Bayside Planning Panel

Item No	5.2
Application Type	Section 82A Review of Determination of DA2016/030
Application Number	DA-2016/030
Lodgement Date	16 March 2017
Property	6 Edgehill Avenue, Botany - Lot B in DP 435717
Owners	Jo Jansyn & Chris Wilson (6 Edgehill Avenue) SR & SD Evans (8 Edgehill Avenue)
Applicant	Jo Jansyn
Proposal	Alterations and first floor additions to an existing single storey semi detached dwelling.
No. of Submissions	One
Cost of Development	\$379,500
Report by	Christopher Mackey, Coordinator Development Services

Planning Assessment Report

Development Application No. DA-2016/030 for the alterations and first floor additions to existing single storey semi detached dwelling at 6 Edgehill Avenue, Botany was refused under delegation on 8 February 2017.

East Elevation

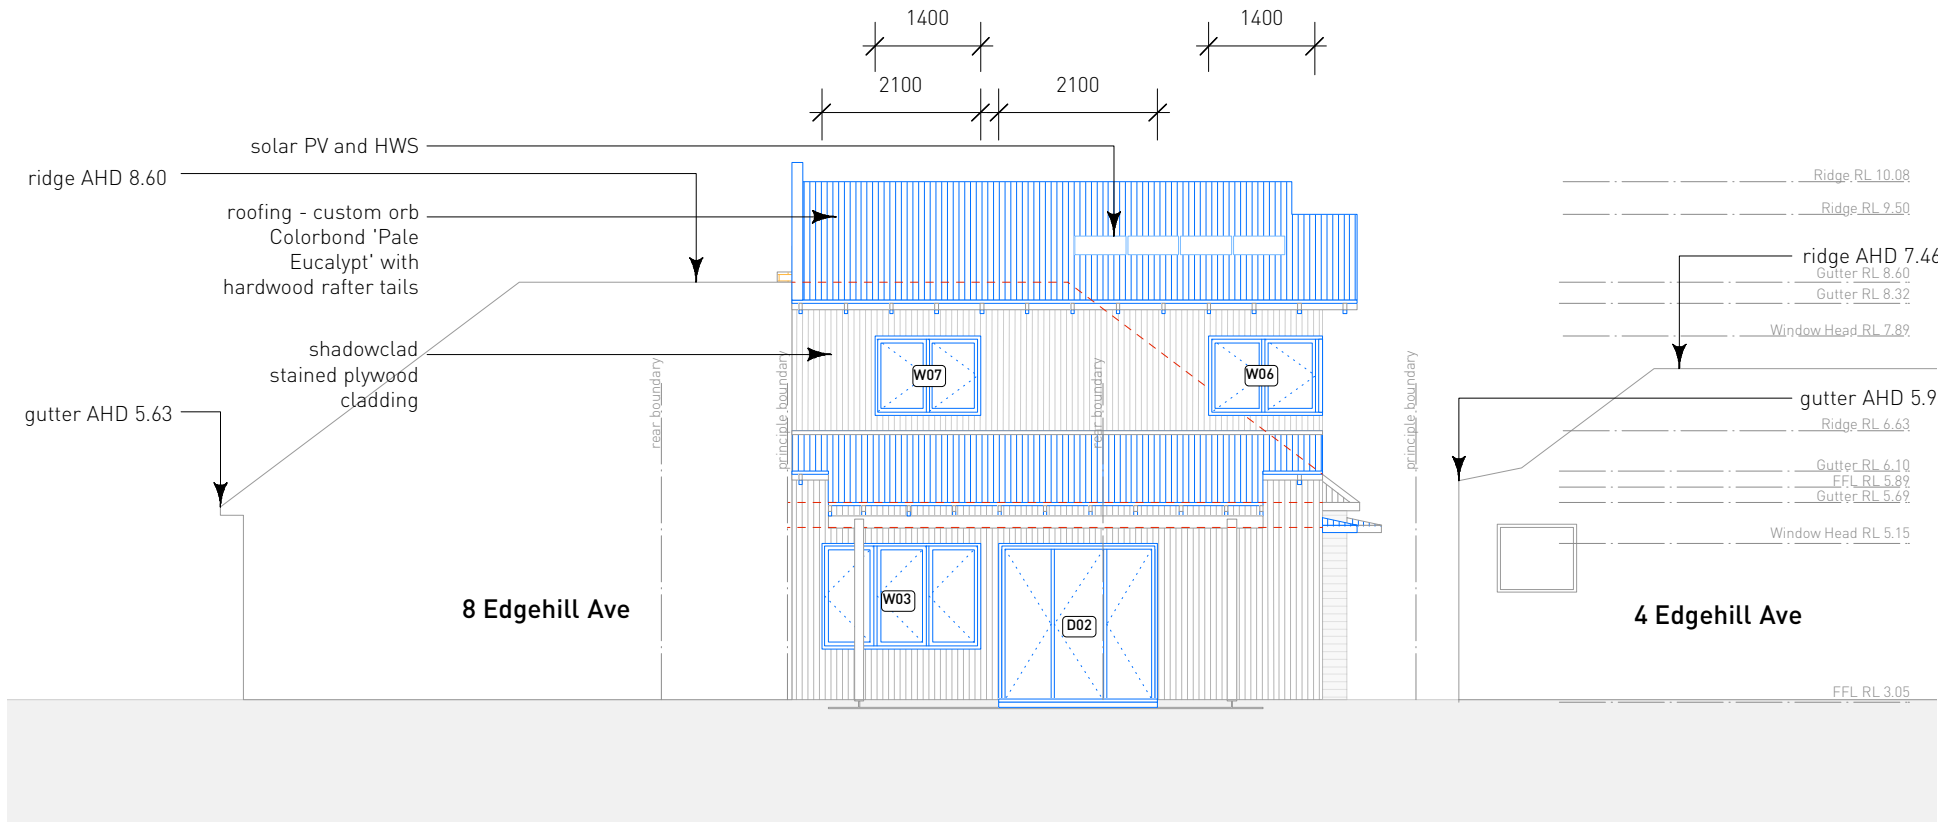
- *Loss of privacy due to first floor addition, the windows in the east elevation will overlook the backyard.*

Officers comment: The windows in the east elevation are from bedroom windows only and to minimise any privacy concerns, privacy screens would be recommended if an approval were granted.
